RE: IN THE MATTER OF THE APPLICATION OF XCEL ENERGY FOR A SITE PERMIT FOR THE UP

TO 250 MW SHERCO 3 SOLAR ENERGY GENERATING SYSTEM IN SHERBURNE COUNTY,

DOCKET NO. E-002/GS-23-217

Northern States Power Company, doing business as Xcel Energy ("Xcel Energy"), submits these reply comments in response to certain comments received during the environmental assessment scoping comment period for the up to 250 MW solar project to be located in Sherburne County, Minnesota ("Project"). These reply comments primarily focus on:

Figure 2. Collection Corridor Alternatives from Unit 09

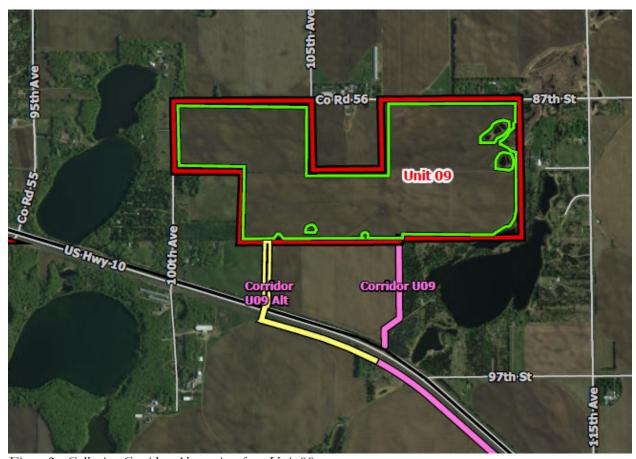
In a comment letter submitted on November 22, 2023, Mr. Jeff Edling, with Edling Farms, expressed concern about the potential for an electrical collection cable crossing his property for the Project. Mr. Edling was concerned about the potential for the collection cable to disrupt his farming operations and damage the soil for future production.

As noted in the Site Permit Application, Xcel Energy has identified two possible collection corridors from Unit 9 to Highway 10, shown in Figure 2 below (excerpted from Exhibit 2 of the site permit application). Both corridors are located along the edge of existing fields in order to minimize impacts to agricultural lands. Any cabling installed in the corridors would be buried underground. Xcel Energy has reached out to the owners of the land, including Mr. Edling and another landowner, crossed by each of the corridor options, to discuss the possibility of securing a voluntary easement across the property of one of the landowners. Easement discussions are

ongoing with both landowners and Xcel Energy is hopeful a voluntary agreement can be reached with one of the landowners prior to the initiation of construction. However, if a voluntary agreement has not been reached, Xcel Energy may elect to secure an easement and pay the affected landowner pursuant to an eminent domain proceeding.

Xcel Energy is sensitive to the concerns of Mr. Edling regarding the potential disruption of his farming operations and the potential impacts to his land. To help minimize the potential impacts to agricultural land, including Mr. Edling's farming operations and land, Xcel Energy prepared an Agricultural Impact Mitigation Plan, which provides means and methods of minimizing the impacts on agricultural soil (See Appendix F of the Site Permit Application). Xcel Energy will continue to coordinate with Mr. Edling and the other landowner regarding the potential to cross their property through a voluntary easement in a way to minimize short- and long-term impacts to the property of the owner whose property will be crossed by the collection infrastructure.

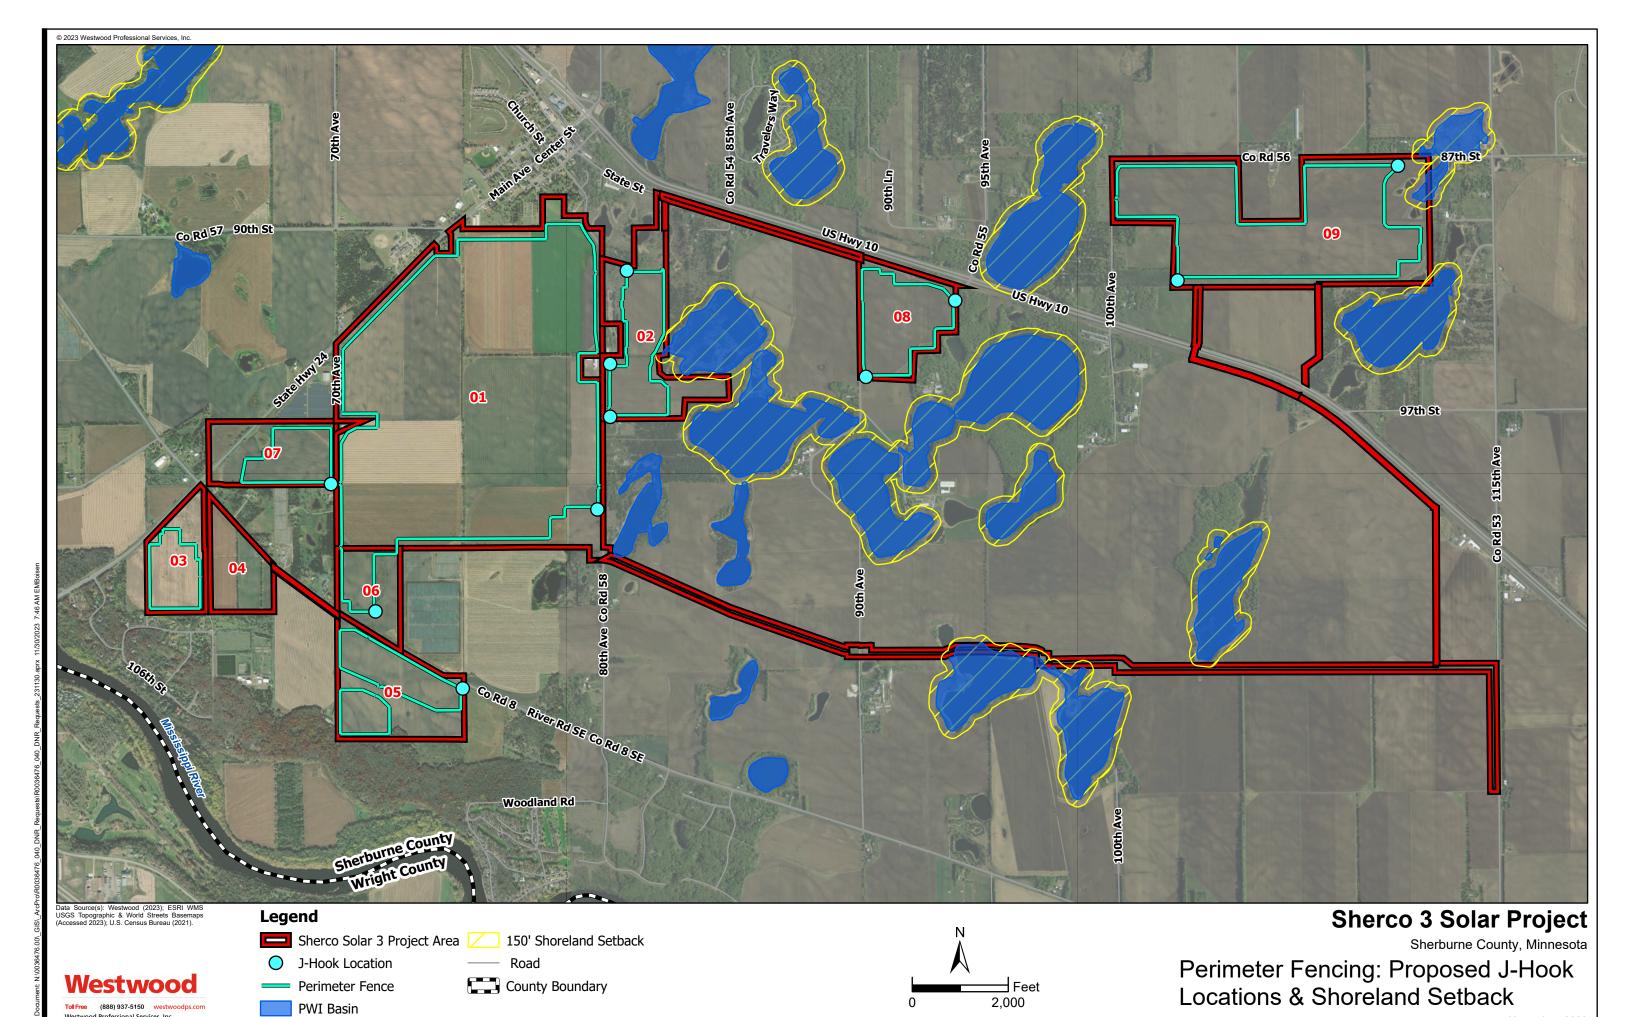
The DNR notes that, in the site permit application figures, it appears that the perimeter fencing is located within the 150' shoreland structure setback near Unit 02. The attached Perimeter Fencing figure shows the location of the perimeter fencing in relation to the 150' shoreland structure setback near Unit 02. At the location in question, on the east side of Unit 02, portions of the fence are located at or outside of the 150' shoreland structure setback. This structure setback will comply with the shoreland ordinance structure setback and will leave room between the fence and the waterbody for wildlife movement.

In addition, the Perimeter Fencing figure also shows locations Xcel Energy has identified for placement of J-hooks, which are mechanisms placed along the fence in strategic locations to redirect turtles and other wetland species back toward areas of safety and away from high use areas such as roads. J-hook locations were determined based on discussions and guidance provided by the DNR as part of the Sherco Solar Project.

Fence & Hydric Soils

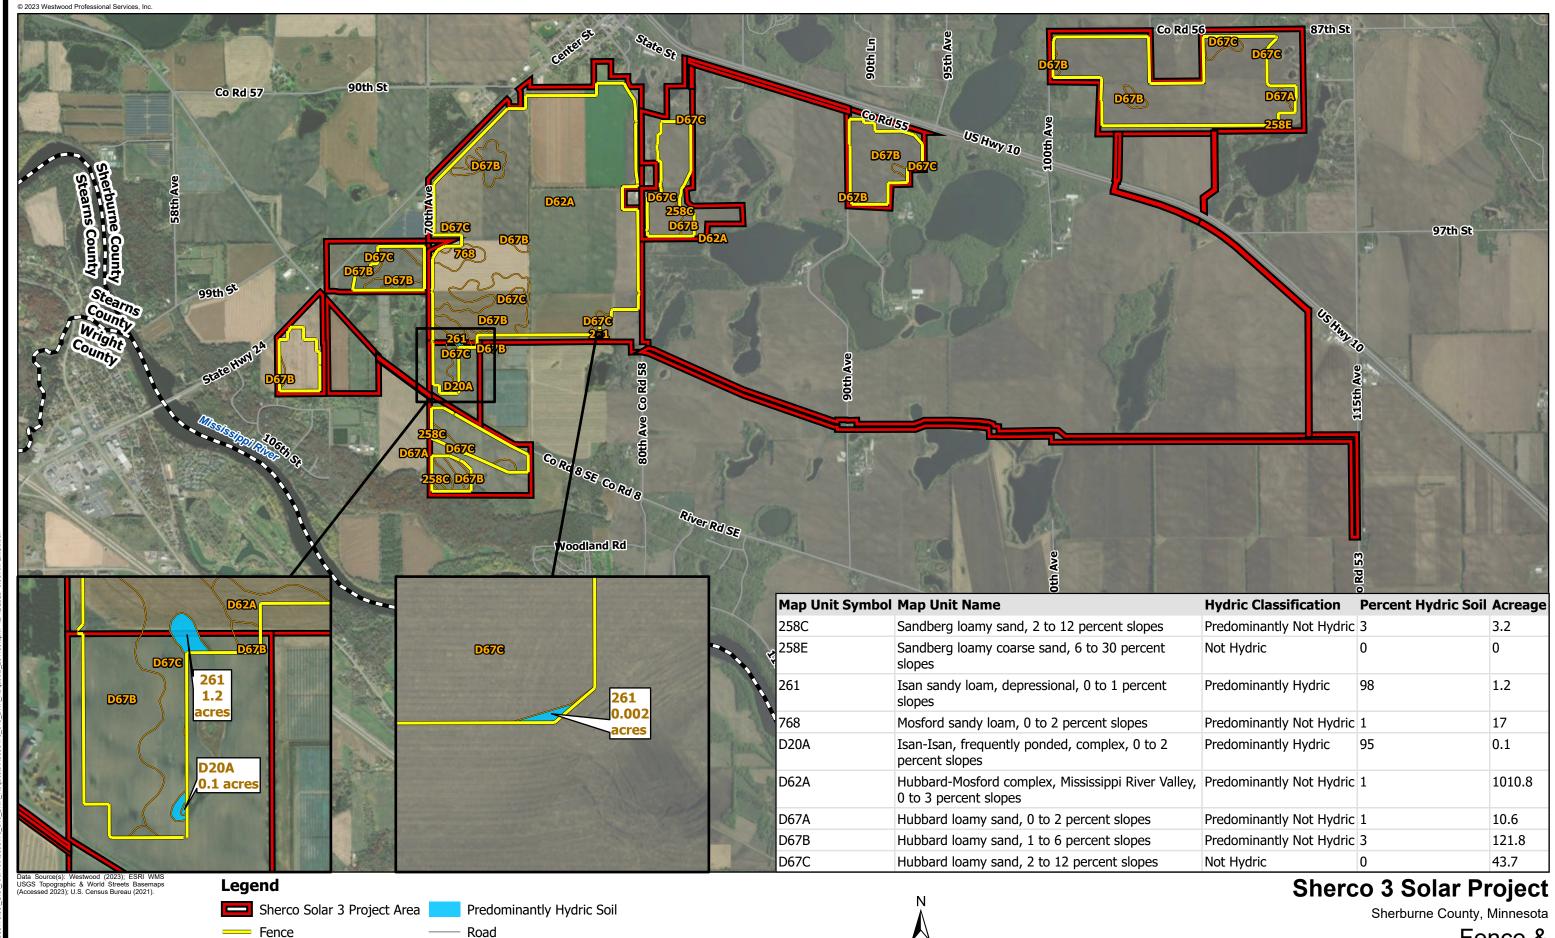
The DNR pointed out that Table 3-9 of the application showed that there were 25.7 acres of hydric soils within the Project area, which could pose issues for site maintenance. This table includes leased land that is outside of the fenced area where facilities will be located. The attached figure Fence & Hydric Soils shows the actual amount of mapped hydric soils within the fence (i.e., the area of the Project that will be converted to solar array uses) totals 1.3 acres. Because these areas are difficult to see at the scale of the full project, inset maps have been included showing those areas at a larger scale. These mapped hydric soils are located outside of delineated wetlands. During the site grading process topsoils are removed and stockpiled before subsoils are borrowed and deposited to create a more level surface. Once site balancing is complete the topsoils are respread and de-compacted. Any potential for saturation or ponding in the non-wetland hydric soil areas that are corrected during construction will be effectively mitigated during this grading process. There will be no grading, installation of fencing or solar arrays within wetlands.
